DATE: 11.06.2019
TO: ProTrak
FROM: Mitesh Baxi
Traffic Engineering

■ **SUNNYVALE DRIVE WAREHOUSE FACILITY [TRC Plan Review]**

Initial Review Note

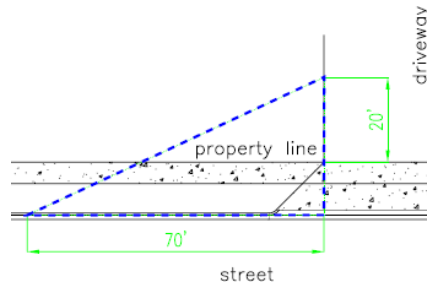
2. Driveways shall be City-standard ramp-type driveways. Show City standard detail(s) on plan. [SD 3-03.3 & 3-03.4 (Vertical curb) CofWTSSM]. Where no curb exists in the vicinity, a flat slab type or a street type entrance may be allowed or required by the City Engineer. [page 7-9 CofWTSSM]
3. The maximum width of the driveway at the gutter flow line measured between the points where the curb returns or driveway apron meets the curb line or edge of roadway is sixty-two (62) feet. [Chapter VII, C, page 7-10 CofWTSSM]. Please coordinate with Engineering for the variance requirements.
4. Show and apply the City’s 20’x70’ sight distance triangle at each driveway on the site plan as per below image. Please dimension. [Sec.18-529(c) (3) CofW LDC] [Sec. 18-812 CofW LDC]
